Subject: Service Bulletin S14XG 8D Battery Cables Routing

Models Affected: 2010 through 2015 Model Year All American Front and Rear Engine Models Equipped with Optional 8 D Batteries

Battery Cable May Contact Battery Compartment Door Reinforcement

Indicates positive cable is contacting compartment door reinforcement

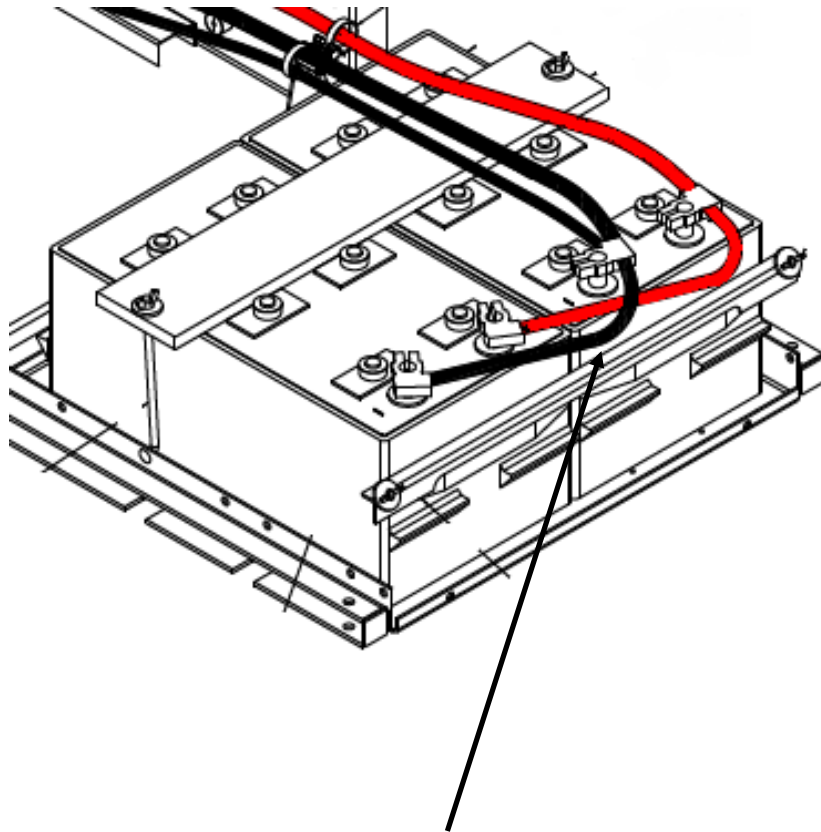
1. Park the bus on a level surface, apply parking brakes, turn off engine and remove keys. Chock wheels.
2. Open the battery compartment door and inspect the positive battery cable in the battery box for signs of contact with the battery compartment door reinforcement when closed.

Inspect positive cable and, if needed, change routing of battery cables to insure proper clearance. Replace positive battery cable if damaged.
